# PlanGrid Task Report - Jun 24, 2024

4 tasks in this report.

**L05059\_Wendell Ford Expy & Hwy 54 FSU**

**#571 [CNTL 512] [NEW] SEC Line voltage cover.**

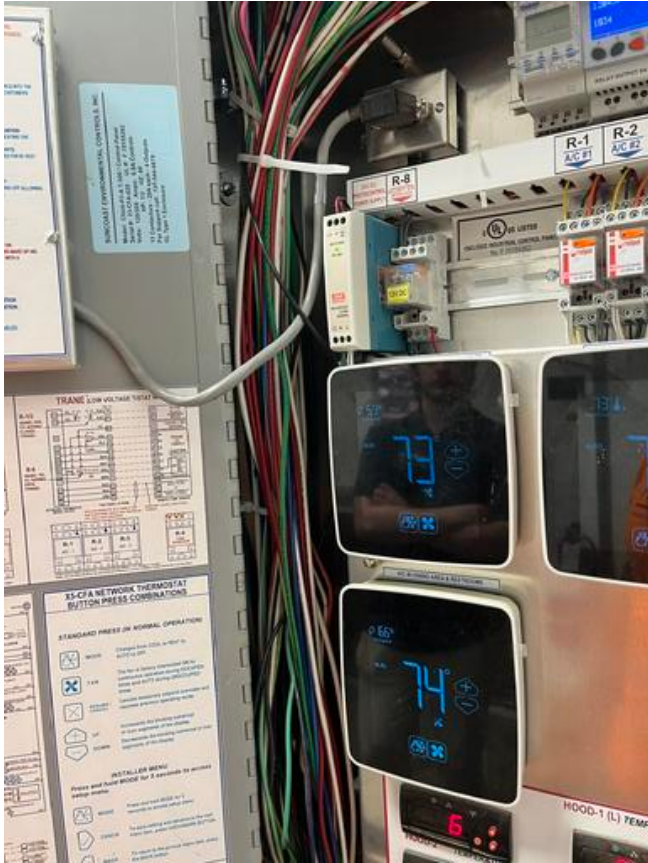
Line voltage cover in SEC low voltage panel is missing and needs to be installed (EC).
